FOCUS ON 12TH APARTMENTS

DRB RECOMMENDATION PACKAGE

900 12th Ave,
Seattle, WA 98122
3039117-LU

03.30.2023

EDG1 MASSING OPTIONS

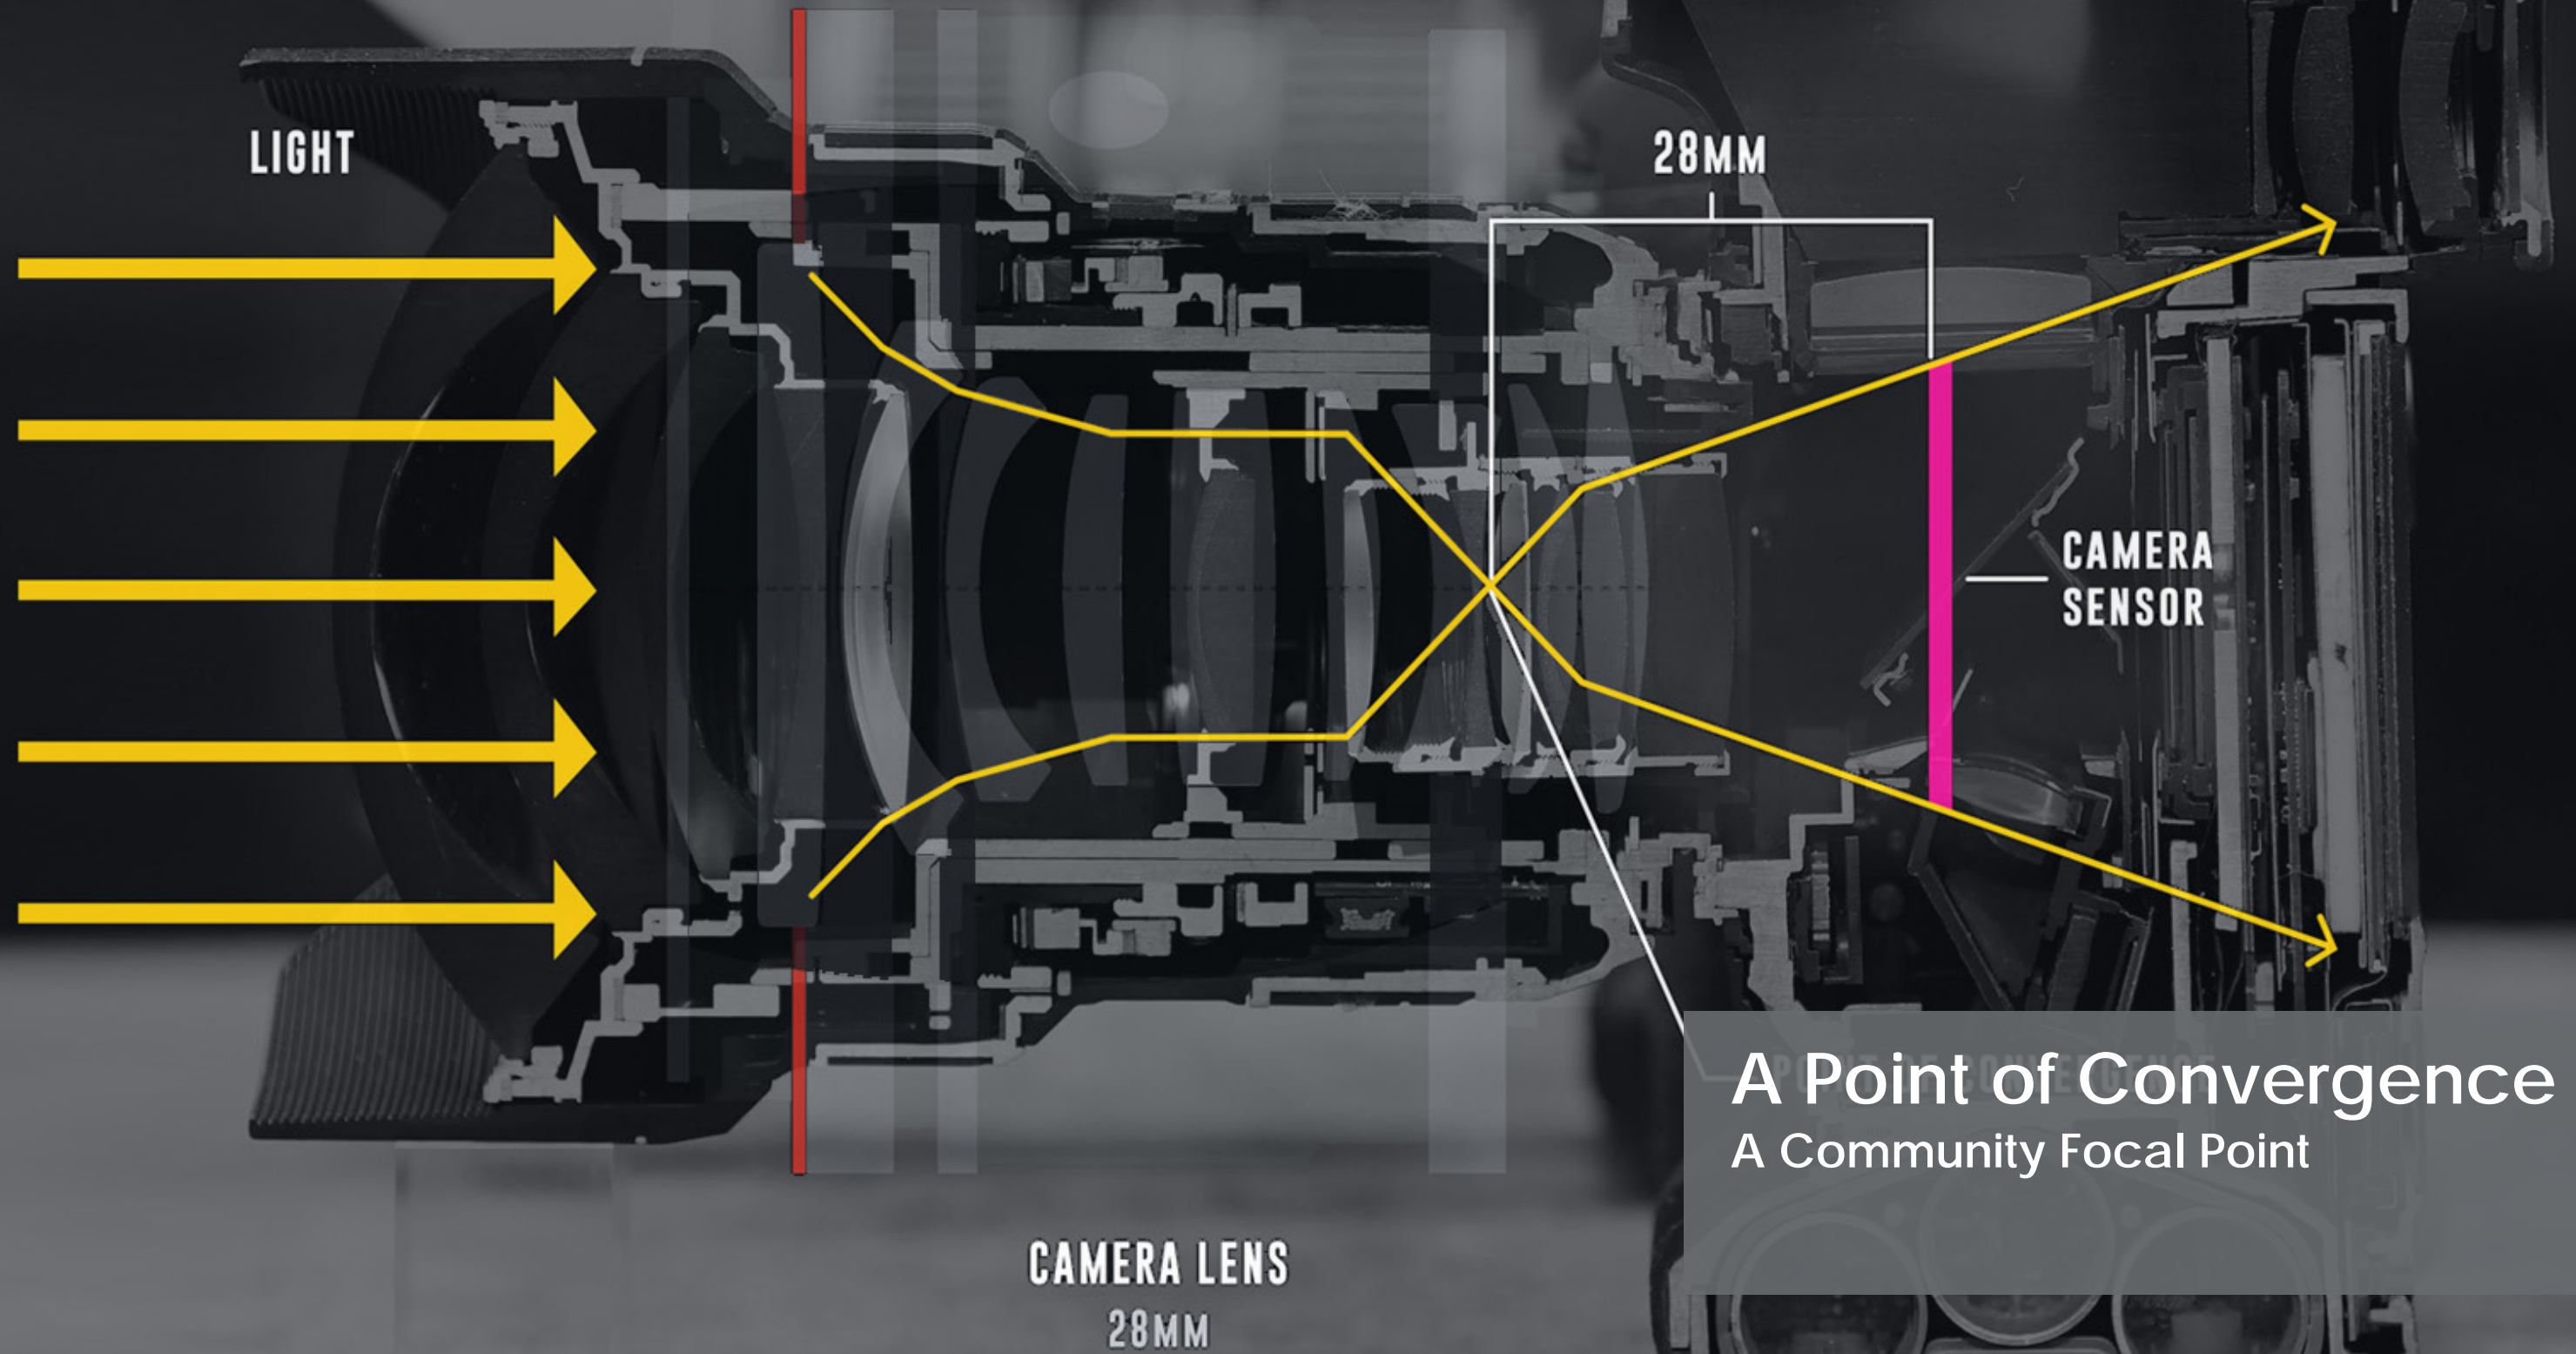
EDG#1 THE BOARD REQUESTED:

1. Massing Options and Zone Transition

A,B,C: Studies that break down the scale of the SE and 13th Ave. side of the building similar to Concept 2 "Interlock". The board suggested that a hybrid of Concept 2 and the large aperture element of Concept 3 would be a successful response to the various scales of the neighborhood.

D,E: Studies of the aperture massing and secondary architectural features to enhance the infill portion of the facade.

F: Attention to the northern facade to ensure appropriate levels of visual interest.

RESPONSE TO EDG#1:

Similar bay-window rhythm from the Option 2 - "Interlock" option has been incorporated into the latest preferred massing option so that the E. Marion St. frontage transitions from the larger scaled "Aperture" massing from the West to the more residential scaled "interlock" massing towards the East.

The applicant has studied some alternatives to the scale of the aperture framing at the SW corner to give the aperture a more dominant corner presence. In the applicant's latest preferred massing the aperture form is further refined with a unifying character that help the building design gradually transition from the "Aperture" language on the west to the "interlock" character to the East.

The north facade against the residential transition zone has been further articulated with bay window ins and outs. The applicant has also shown fenestration and window patterning locations to better communicate where blank wall conditions exists and some initial ideas on how those could be mitigated.

E. MARION ST. ARTWALL AND GARAGE ENTRY

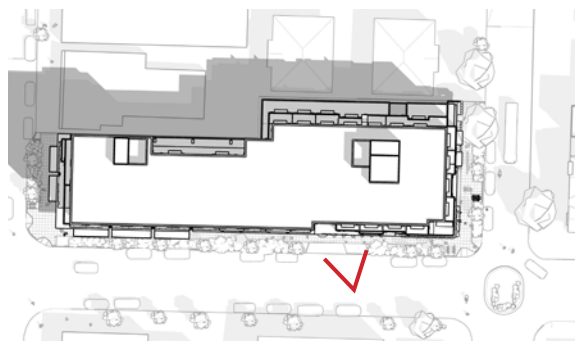
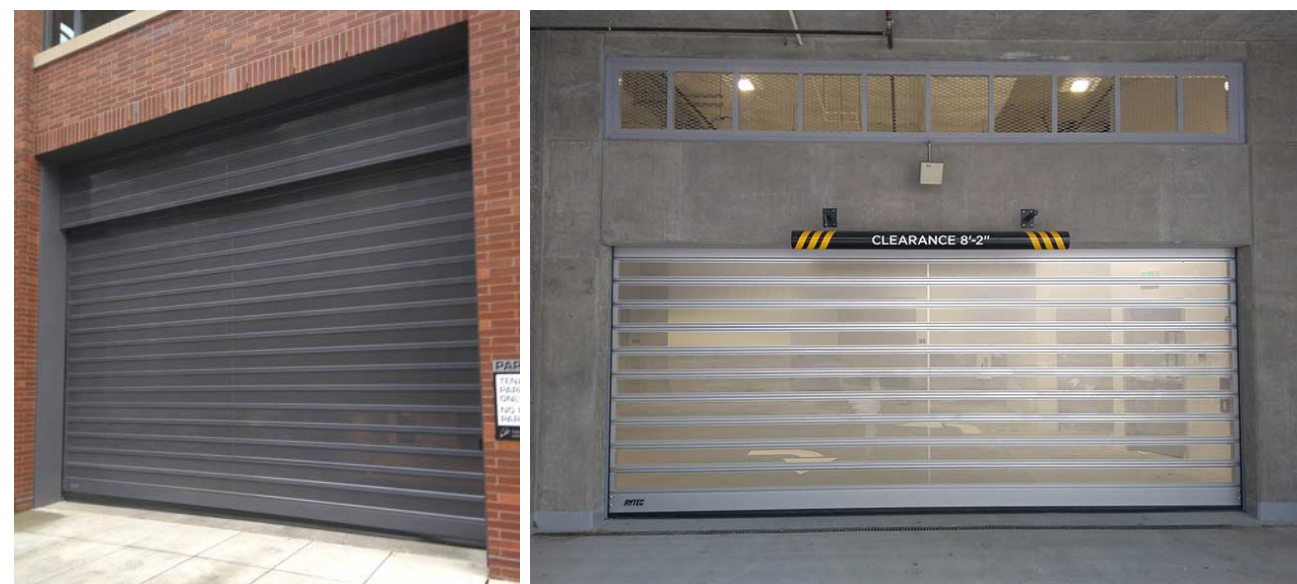
f. Although the Board supported the relocated solid waste room and vehicle access from 13th Ave to E Marion St, the Board was concerned with the amount of blank wall created by the garage opening and solid wall of the service room on E Marion St. Moving forward, the Board gave guidance to study ways to mitigate the impacts of the blank wall, such as a combination of taller landscaping, art, special materials, and seating, in order to provide visual interest along this portion of the E Marion St ground-level façade.

An art wall with content curated through collaboration with local artists and/or the photography school is being proposed as a feature element for the solid wall of the service room. The design team sees this as an opportunity for an engaging and revolving art program element along E Marion St. that is rooted in the history of the neighborhood.

An art wall with content curated through collaboration with local artists and/or the photography school is being proposed as a feature element for the solid wall of the service room. The design team sees this as an opportunity for an engaging and revolving art program element along E Marion St. that is rooted in the history of the neighborhood.

SE CORNER VIEW COMPARISON WITH AND WITHOUT DEPARTURE #1

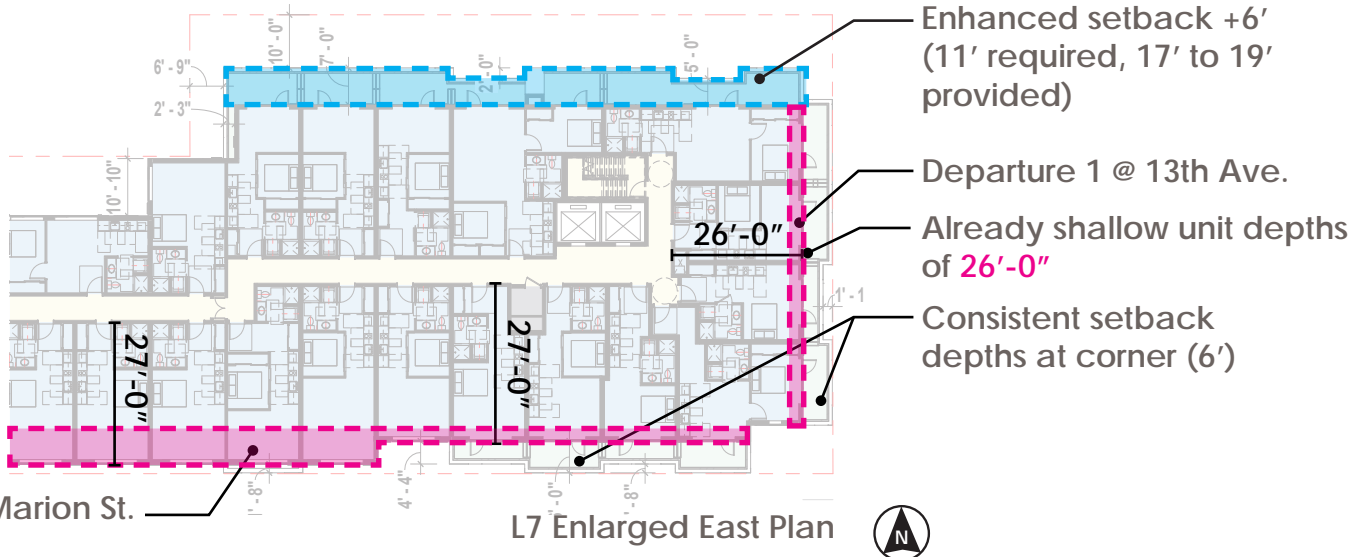
b. The Board appreciated the retention of upper-level setbacks around the eastern end of the massing since EDG #1 and the Board supported the extent of the upper-level setbacks proposed on massing Concept 5. The Board was concerned, however, with the depth of the 6 feet upper-level setback proposed on the east façade and whether the less than code required setback (8 feet) adequately helped to mitigate the perceived height of the building when viewed from the intersection of E Marion St and 13th Ave and successfully responded to the transition to the lower height zone to the north. The Board strongly recommended providing the required upper-level setback at the east façade or provide further justification for how the reduced setback better mitigates the perceived height of the building, or would lead to reduced setbacks elsewhere on the building that might have a greater negative impact on the transition to the lower zone.

The board had indicated support for the applicant's departure request from the upper-level setbacks along the south AND east face of the massing in EDG1 and only during EDG2 back tracked a little to question the departure at the east face while still supporting the south elevation setback departures. The applicant would still like to seek a 2' reduction of the east façade upper-level setback from 8' to 6' and will demonstrate in perspective views that the impact of the reduction is negligible from the street. In providing the reduction, the applicant would be better able to accommodate deeper voluntary setbacks along the north façade of the project to help the overall massing better transition to a lower height zone at a shared lot line towards the north, a feature that the board supports. Furthermore, in refining the design of the building, the entire south façade above L1 has been additionally set back by 2' from the street which works towards mitigating the overall perceived height of the building.

RECAP OF EDG #1 GROUND LEVEL GUIDANCE

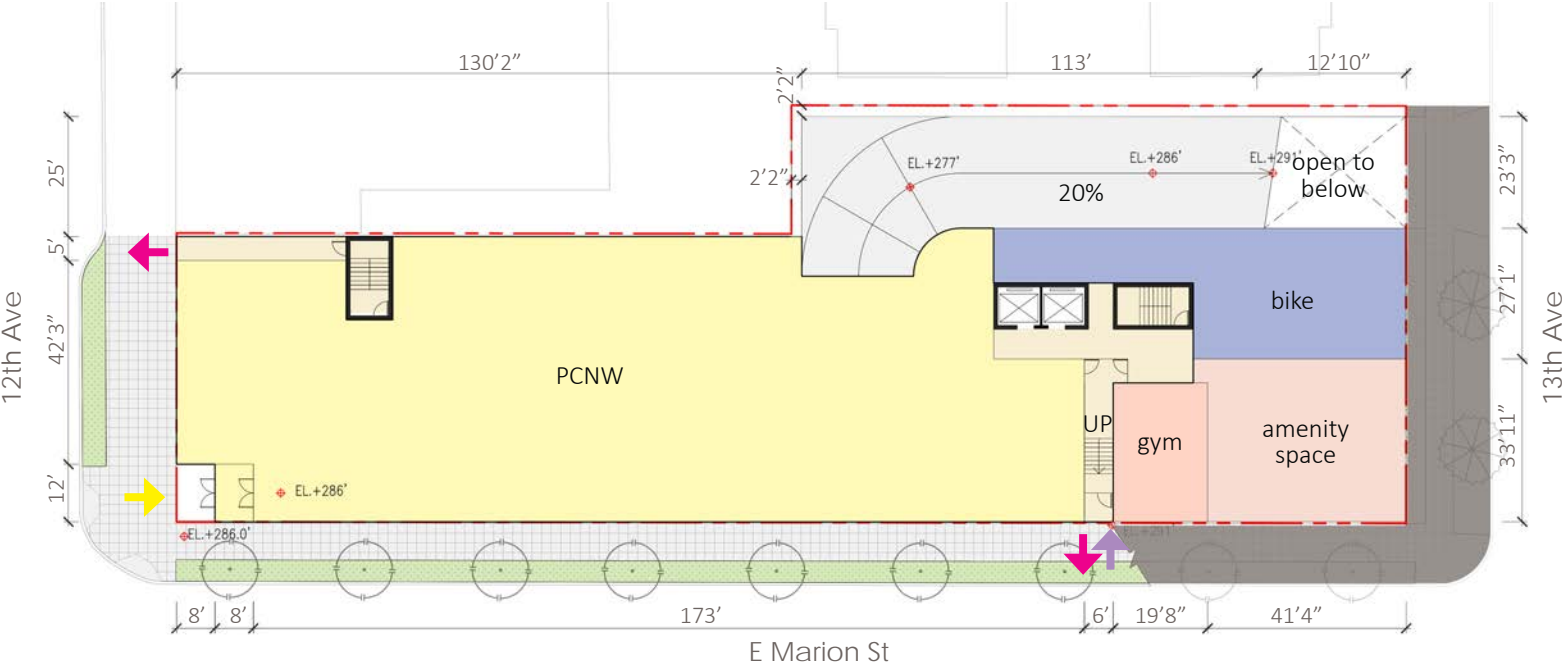
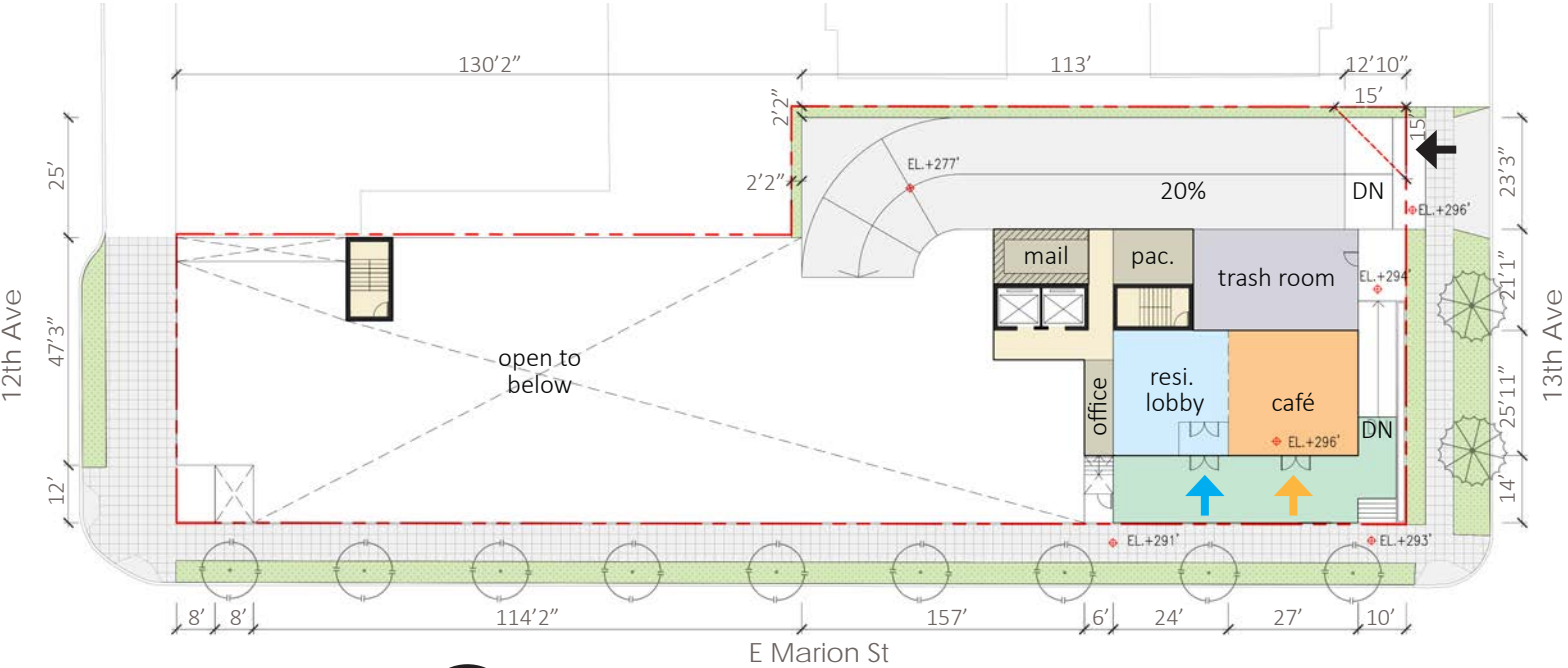
EDG#1: THE BOARD REQUESTED:

2. Right-of-Way Street Trees, Ground Level Uses, and Street Activation:
- A,C: Additional studies that move the garage entry and trash room to E. Marion St. to avoid the removal of the exceptional street tree on 13th Ave. and to free up space for residential uses along 13th.

RESPONSE: The applicant's latest preferred ground level plan relocates both the garage entry and trash room and servicing to E Marion St. This saves the Exceptional tree on 13th. The applicant is also proposing ground level apartment units with their own sidewalk level porches along 13th ave. The latest preferred plans now has only residential uses fronting 13th ave.

RESPONSE: With the relocation of the garage ramp and the trash room, the Applicant has revised the residential lobby plan and moved the location of the residential entry to 13th Ave. where it is now more closely aligned with the elevation of the sidewalk. The number of stairs and accessible ramp lengths have been reduced and the ramp now is perpendicular to the sidewalk. Bike parking is accessed via a direct entry door off E Marion st. down to the bike parking room on L1. Stair "wheel ramps" will be provided for ease of transporting bikes up and down one short flight of stairs. (about 6' of elevation change)
